Technical Note

Project: Wicks Farm, Ford

Subject: Response to West Sussex Highways request for additional Information.

Rev	Description	Dm	Ch	Date
REVISIONS				
Preliminary	Approval	Tender	Consent	
DRAWING STATUS				
DATE	DRAWN	CHECKED	ISSUE CHECKBOX	
AUGUST 2019	BEB	DLW		
DRAWING No.	REV	SCALE		
6352.002	.	1:500	@ A3

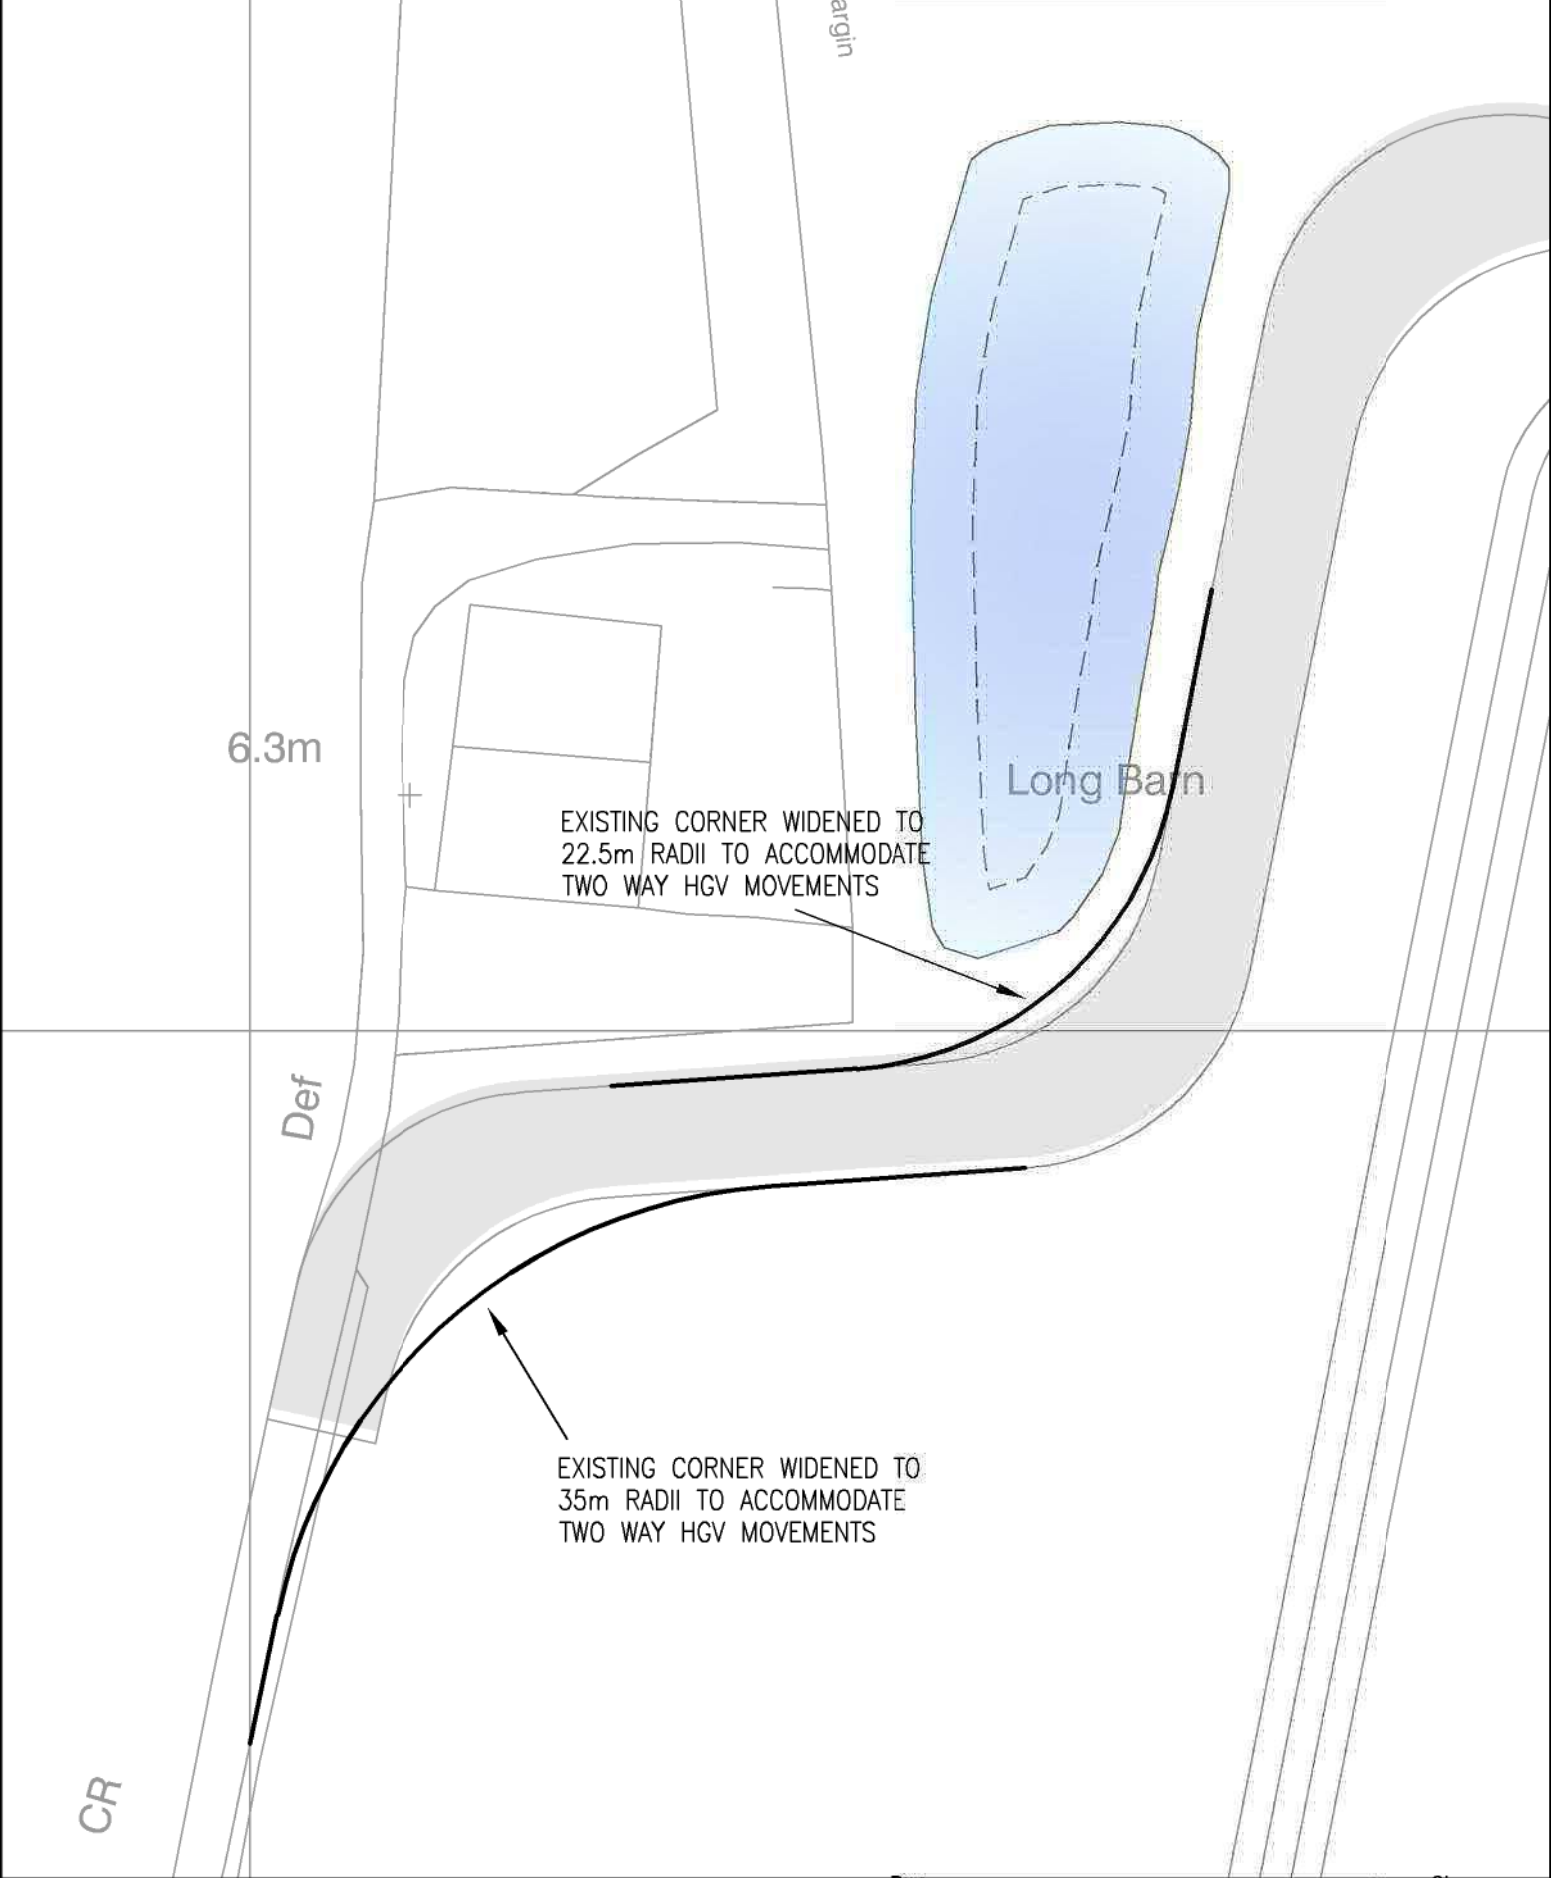
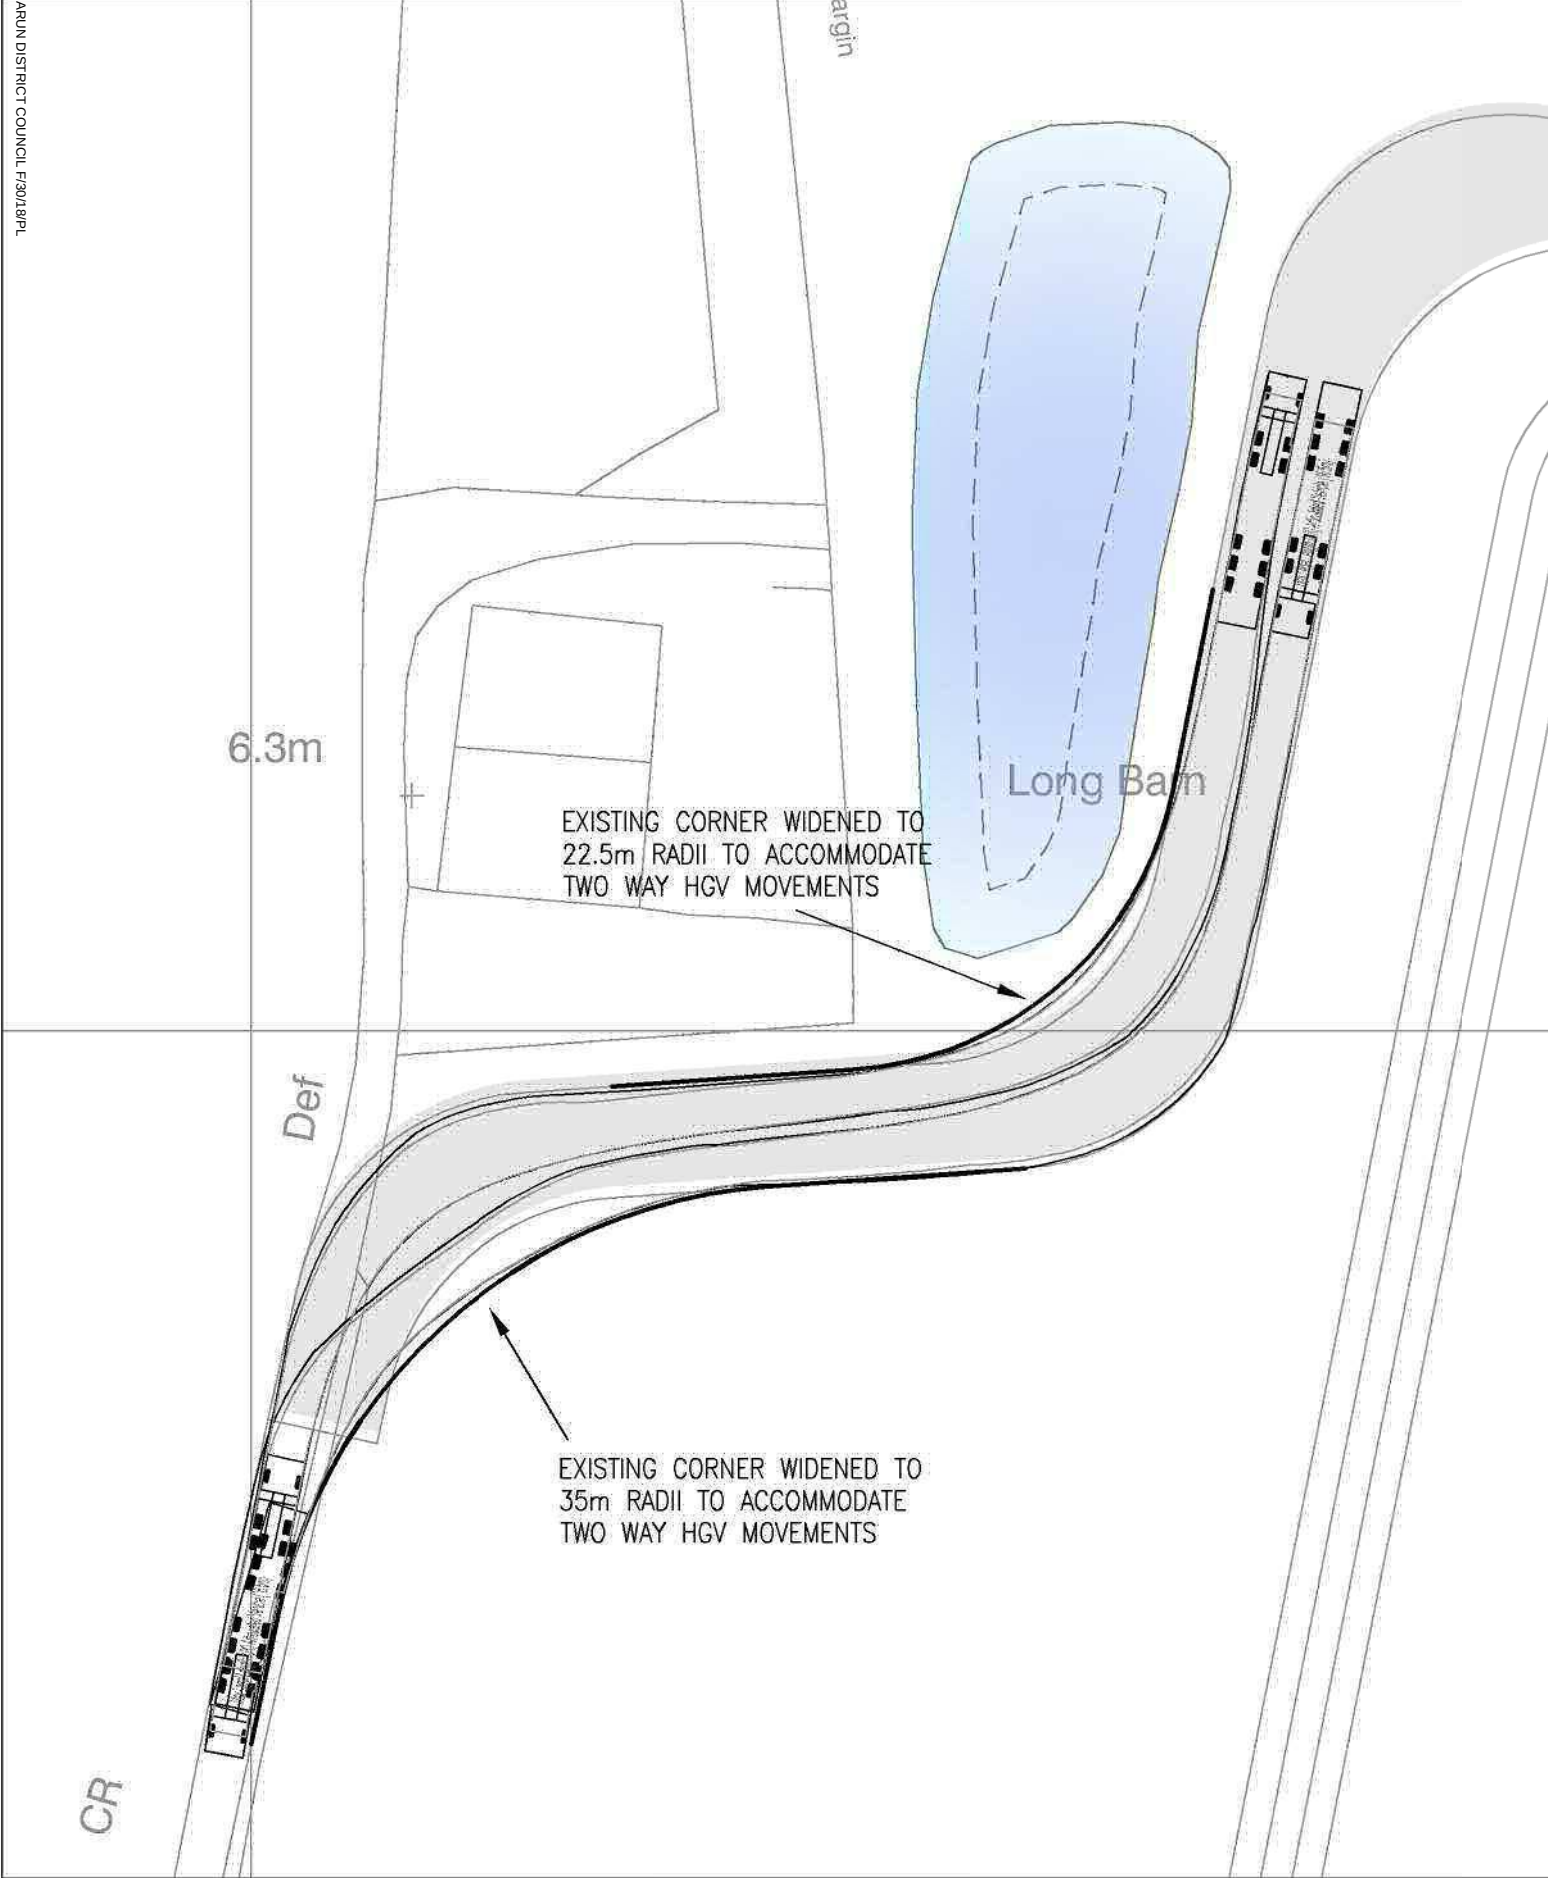
Swept path tracking demonstrating the largest anticipated vehicle entering the site, travelling through the site, turning and exiting the site.

- 1.14. This allows an HGV to turn into the access road and, should another HGV be leaving the site at the time, be able to wait without any of the vehicle overhanging on to Ford Lane. The

drawing shows that there is suitable space on this access for the HGV's to pass each other without causing an obstruction on Ford Lane.
